Wiring Upgrade Guide

Use when replacing SICK models LCUX1-400 (part number 1013410) with model UE48-2OS3D2 (part number 6024916).

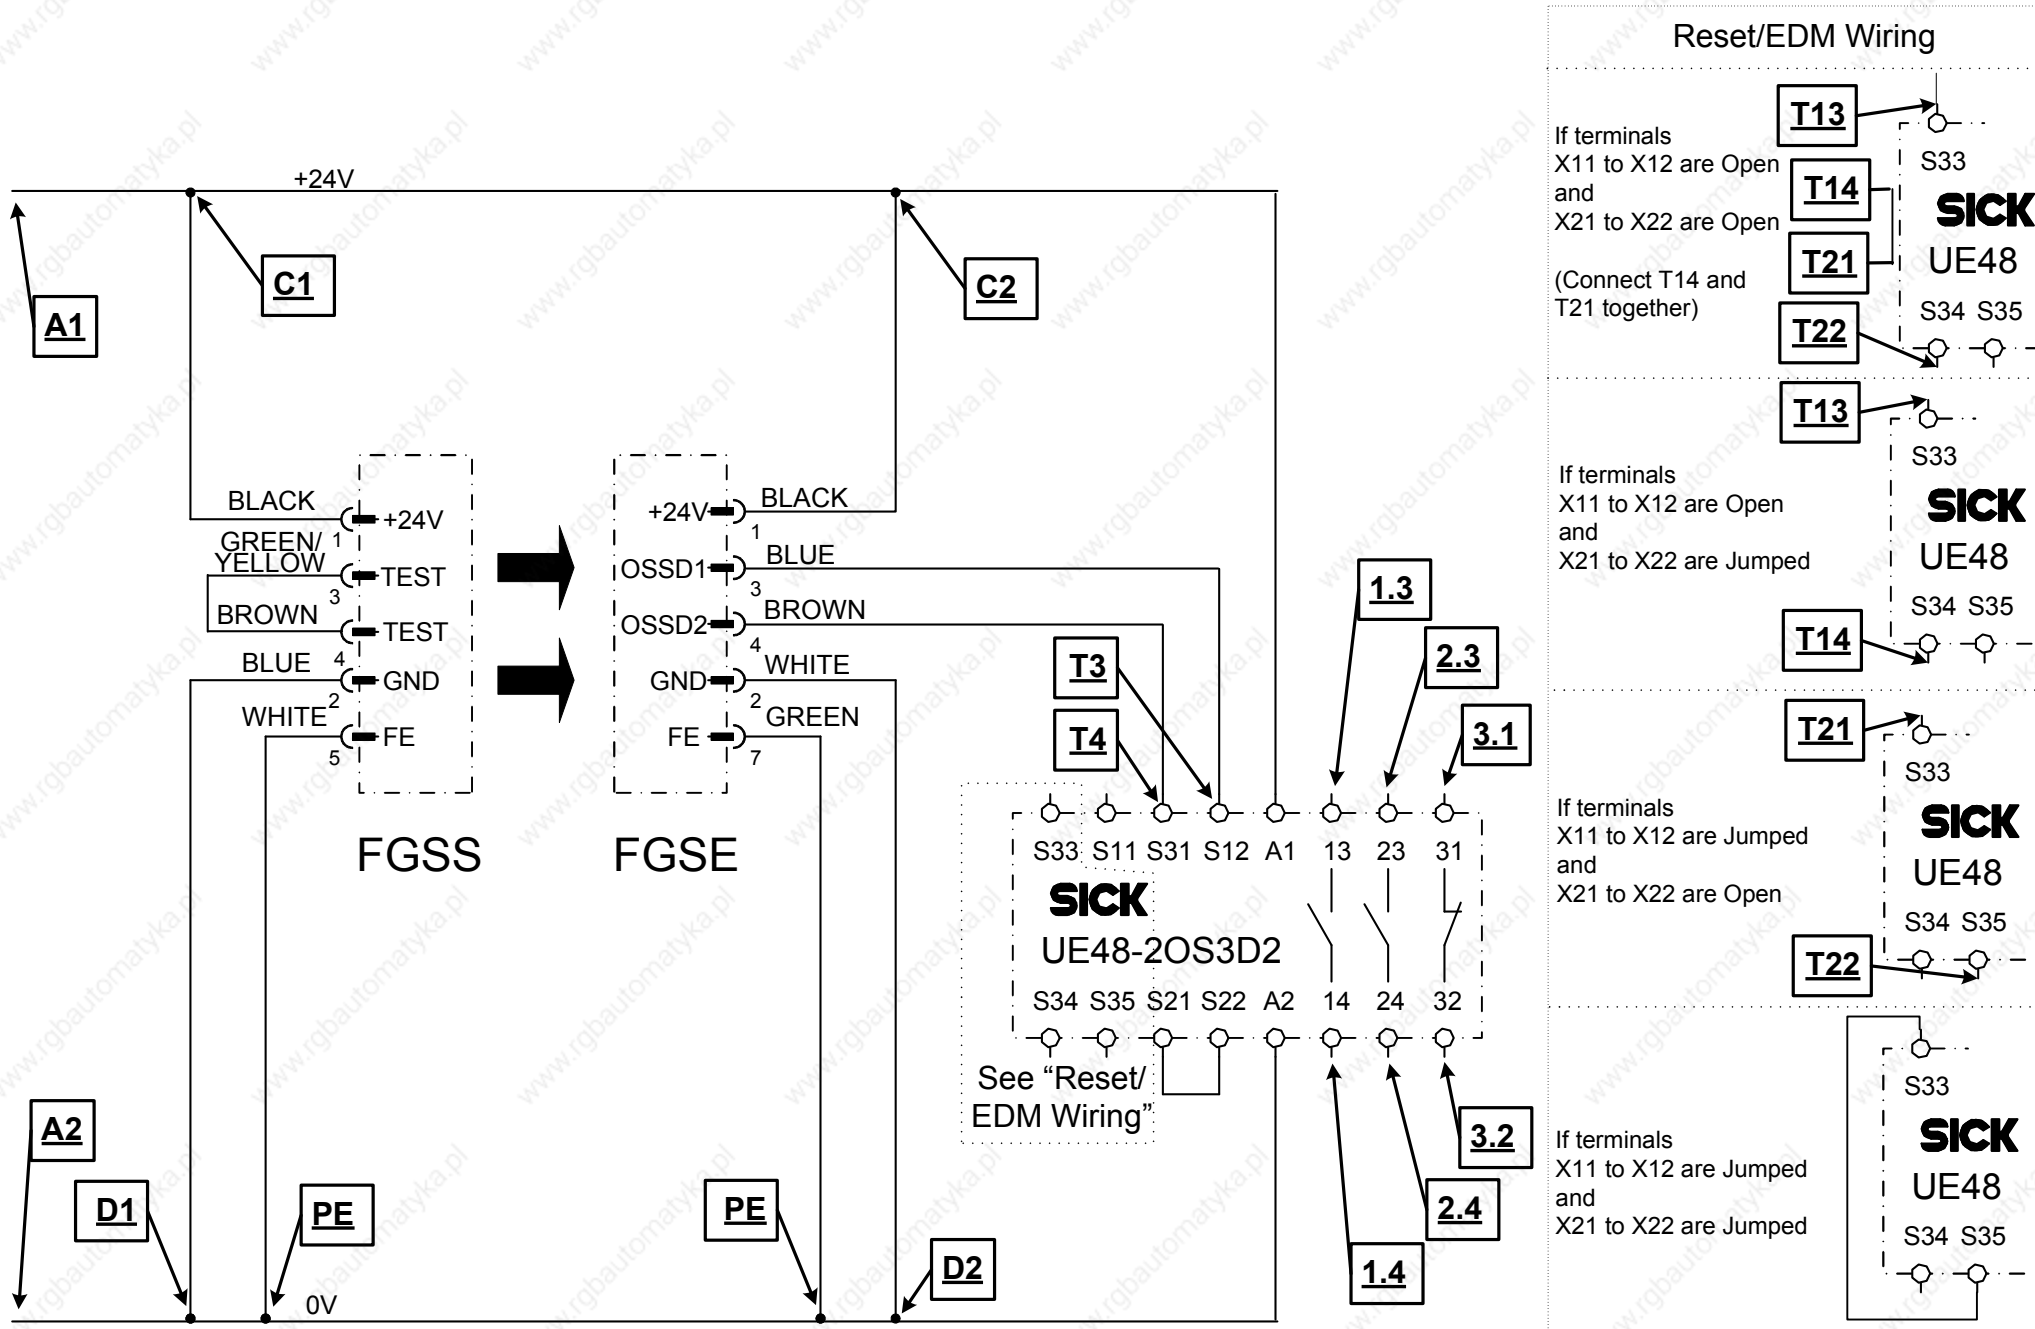
LCUX1-400 terminal designations are underlined. Attach the existing wires from the LCUX1-400 terminals as shown below.
